**From:** Kimberly Lehmborg  
**Sent:** Monday, July 01, 2013 9:21 AM  
**To:** Debbie Tarry  
**Cc:** Rachael Markle; Paul Cohen; Carolyn Wurdeman; Heidi Costello  
**Subject:** RE: Green Development Code

**From:** Jesse Salomon <[jsalomon@shorelinewa.gov](mailto:jsalomon@shorelinewa.gov)>  
**Date:** June 30, 2013, 10:02:48 PM PDT  
**To:** Debbie Tarry <[dtarry@shorelinewa.gov](mailto:dtarry@shorelinewa.gov)>, Julie Underwood  
<[junderwood@shorelinewa.gov](mailto:junderwood@shorelinewa.gov)>, Paul Cohen <[pcohen@shorelinewa.gov](mailto:pcohen@shorelinewa.gov)>  
**Subject: Green Development Code**

## The Horizontal Plane - Full Cutoff Fixture No light fixture visible above 90 degrees

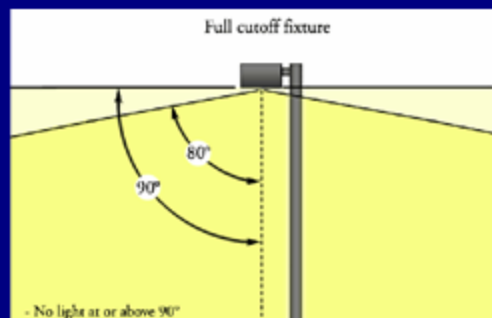
For flood lights, please define above horizontal plane. Is it ok to have one as long as it is 90 degrees angle or less?

Yes, the horizontal plane is defined as no fixture visible above 90 degrees.
